UNITED STATES
NUCLEAR REGULATORY COMMISSION
WASHINGTON, D.C. 20555-0001

LICENSEES: ENTERGY OPERATIONS, INC. AND COMMONWEALTH EDISON
SUBJECT: SUMMARY OF PUBLIC MEETING ON FLEXIBLE-WEDGE GATE VALVE
PRESSURE LOCKING THRUST METHODOLOGIES (TAC NOS. M93467,
M93434, M93435, M93441, M93442, M93458, M93459, M93477,
M93478, M93509, M93510, M93541, M93542)

NRC Meeting to Discuss Pressure Locking Thrust Prediction Methodologies

ComEd PRESSURE LOCKING METHODOLOGY AND TEST PROGRAM

**Predicted Unseating Thrust Vs. Measured Unseating Thrust
for 14" -900# Powell Valve**

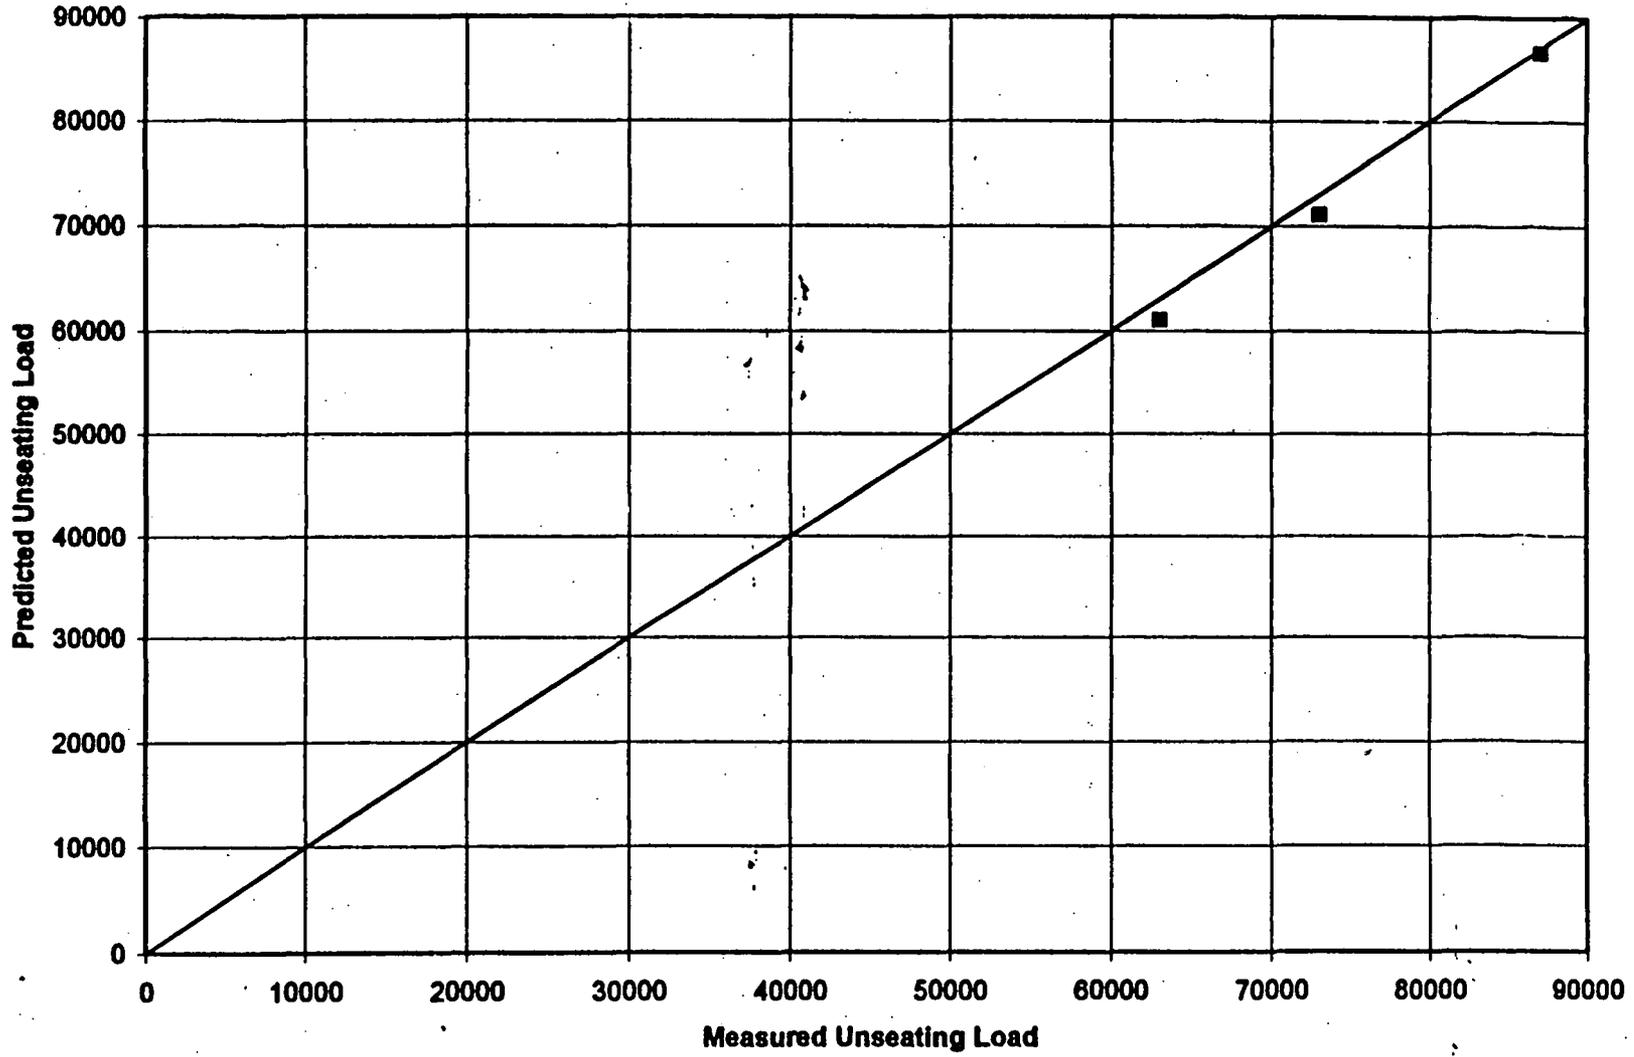
1. In some instances the EOI pressure locking prediction methodology underestimated the amount of thrust required open the Crane, Walworth and Westinghouse valves during pressure locking conditions and consistently underestimated the amount of thrust required to open the Borg-Warner valve during pressure locking conditions.

**Predicted Unseating Thrust Vs. Measured Unseating Thrust
for 6" -600# Walworth Valve
(All Data Points)**

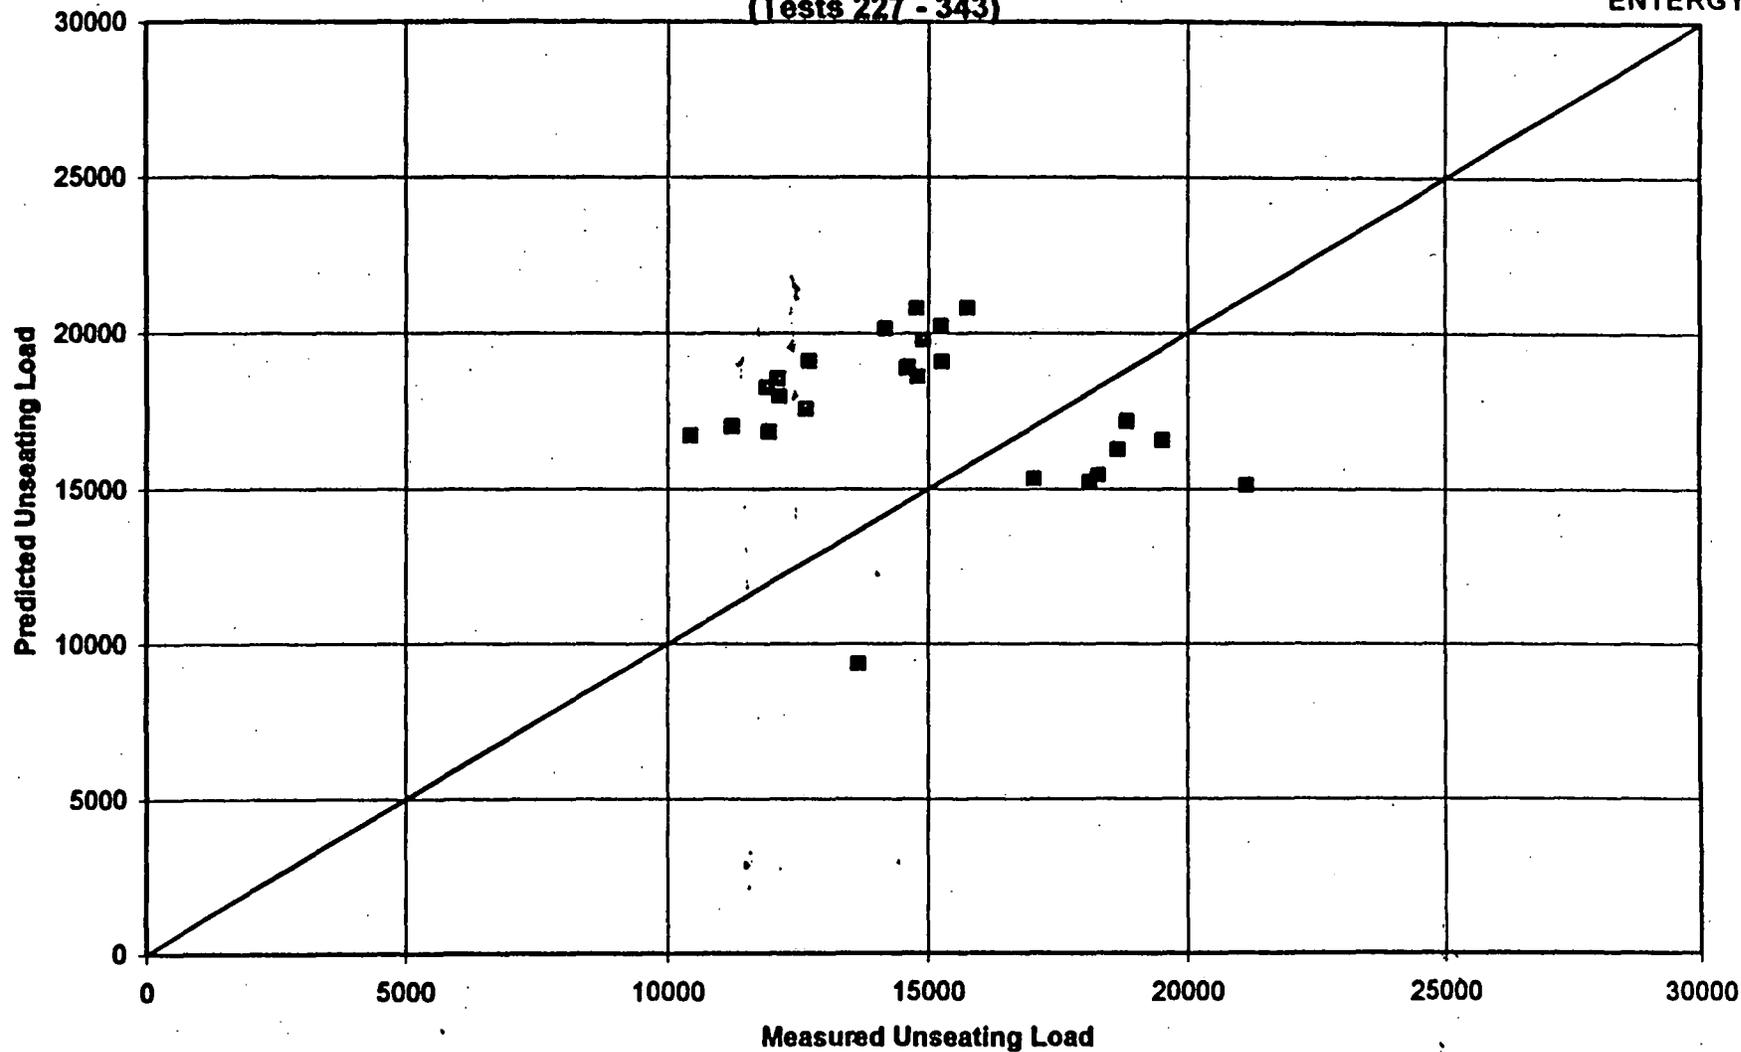
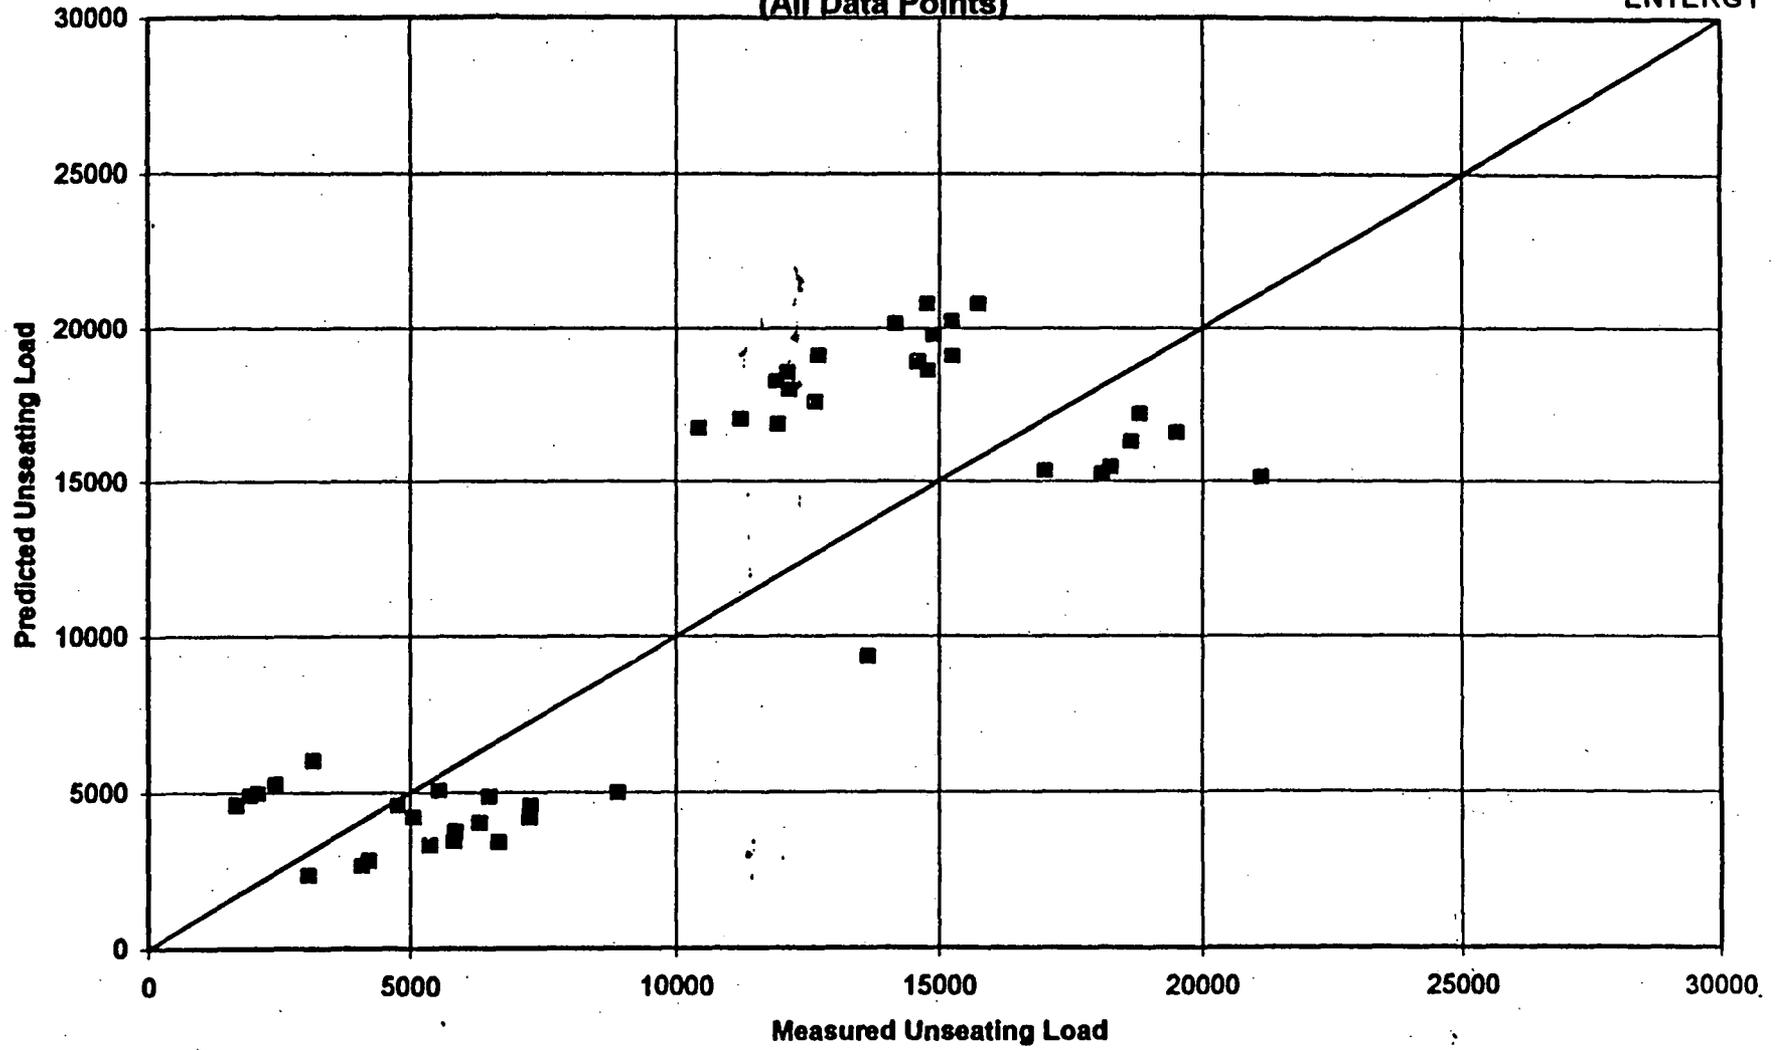
3. Pressure locking test results from the Walworth valve indicated that as the differential pressure between the bonnet and the downstream (or upstream) side of the valve increases, the stem thrust required to open the pressure locked valve increases (see Attachment 5, INEEL pressure locking tests numbers 208 through 215, 217, 218, 230, 231 and 232). The EOI pressure locking methodology predicted that the opposite would occur in that as the differential pressure between the bonnet and downstream (or upstream) side of the valve increased the stem thrust predicted to open the pressure locked valve decreased. Many of the INEEL tests involved upstream or downstream pressure of 0 psig or very close to 0 psig; however, in test numbers 217 and 218 the upstream and downstream pressures were significantly greater than 0 psig. During the meeting, EOI stated that it does not apply the pressure locking prediction methodology to scenarios where upstream or downstream pressure is 0 psig. However, this does not explain why the methodology is not consistent with the test data nor does it resolve the issue when upstream or downstream pressures are present. The NRC staff questioned why the EOI pressure locking thrust methodology prediction conflicts with the Walworth valve test results. Are there any differential pressure restrictions or other conditions associated with the use of the EOI pressure locking prediction methodology?

1. In some instances the ComEd pressure locking prediction methodology underestimated the amount of thrust required to open the Walworth valve under pressure locking conditions and consistently underestimated the amount of thrust required to open the Borg-Warner valve under pressure locking conditions. The NRC staff realizes that enhancements to the ComEd pressure locking thrust prediction methodology are being evaluated. Is the ComEd pressure locking thrust prediction methodology (current or enhanced version) applicable to all flexible wedge gate valves or is the methodology limited to specific flexible wedge gate valves?
2. The ComEd pressure locking prediction model did not account for differential pressure across the disk hub. The importance of this parameter in developing an accurate methodology needs to be addressed.

GRAPH 6
Predicted Versus Measured Portion of
Unseating Thrust Due to Pressure Forces
for Borg-Warner Valve

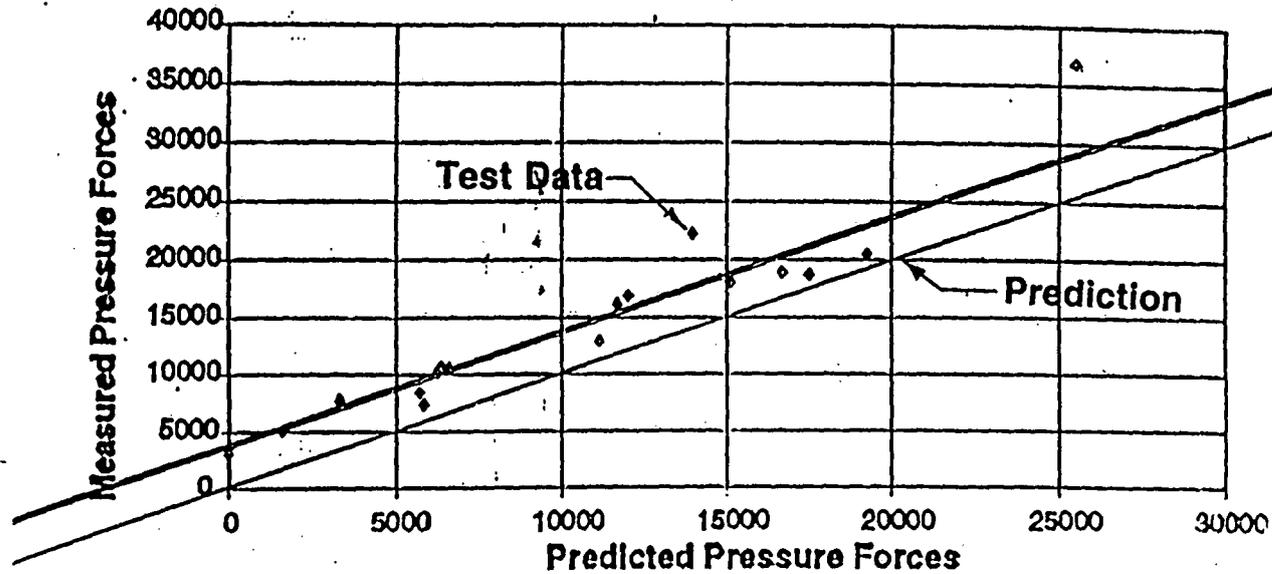
- Errors in ComEd's Prediction vs. Test Results for Valve 3 as high as 60%
- Predictions unconservative

Thrust Trends Using Both the ComEd and Grand Gulf Methods

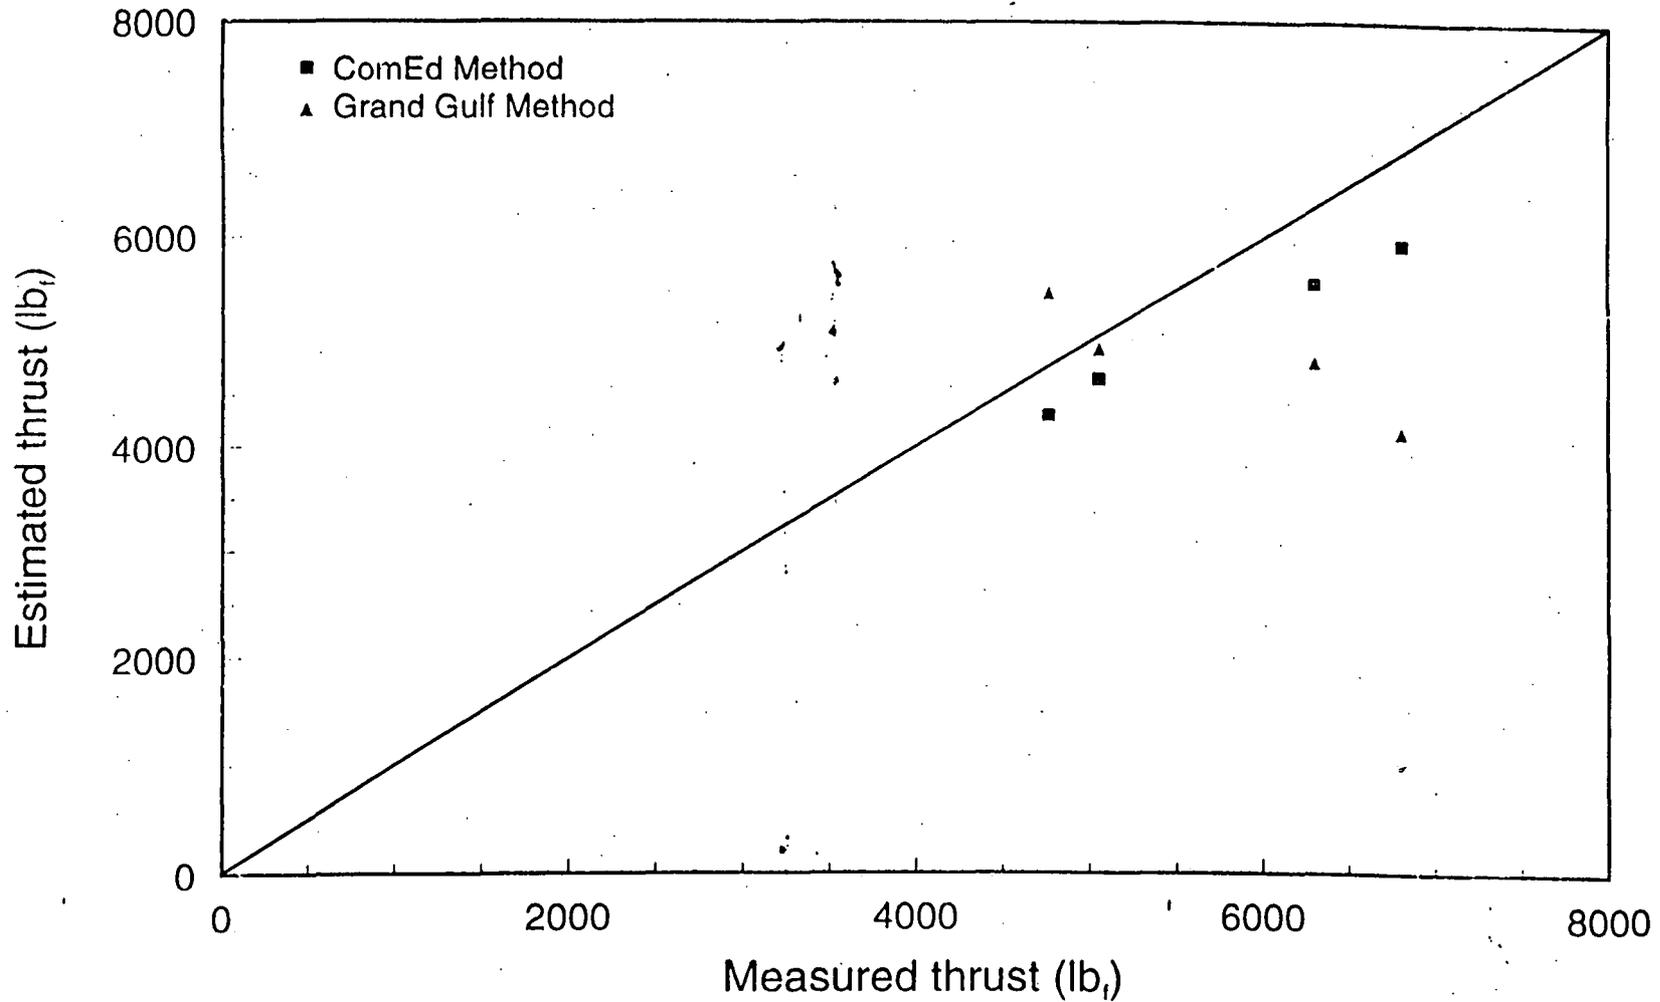
- Both methods underestimate the stem thrust required to open a valve that is pressure locked.
- Both methods underestimate less using conditions prior to valve motion.
- Selected trends of the Grand Gulf Method are inconsistent with test data.
